UNITED WIRELINE SERVICES, INC.  
P.O. BOX 1304  
MATTOON, ILLINOIS 61938

MAY 28, 1985

REF; LICENSE NO. 12-24320-01

NOTICE OF VIOLATION

# UNITED WIRELINE SERVICES, INC. Monthly Shop Monitor

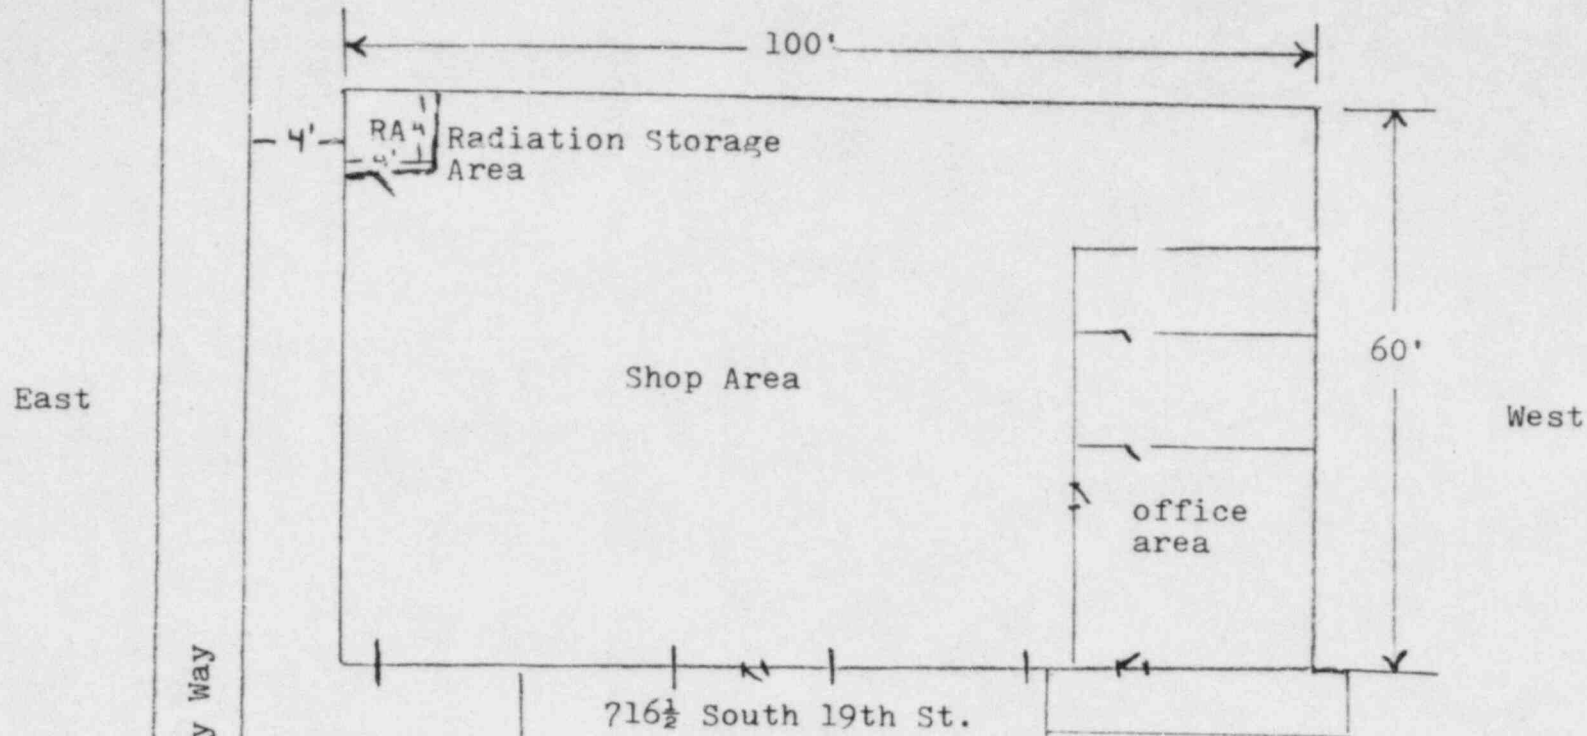
1. License Condition No. 17 requires that licensed material be possessed and used in accordance with the statements, representations, and procedures contained in certain referenced applications and letters. Appendix B, Section I(a)(1)(2) of the Storage, Operating and Emergency Procedures Manual submitted as part of the application dated March 23, 1984, states that licensed material will be stored in storage pits (downhole), or in a steel bunker with a locking device.

Contrary to this requirement, licensed material has been stored above ground, on a wooden pallet, and with no locking device since January 23, 1985.

ALL LICENSE MATERIAL WILL BE HOUSED AND STORED IN SHOP DESIGNATED AREA, ENCLOSED WITH A FOUR FOOT BY FOUR FOOT WOOD FRAME STRUCTURE WITH LOCKING DOOR, ALSO LABELED WITH THE APPROPRIATE (CAUTION RADIOACTIVE MATERIALS). (SEE SKETCH ENCLOSED)
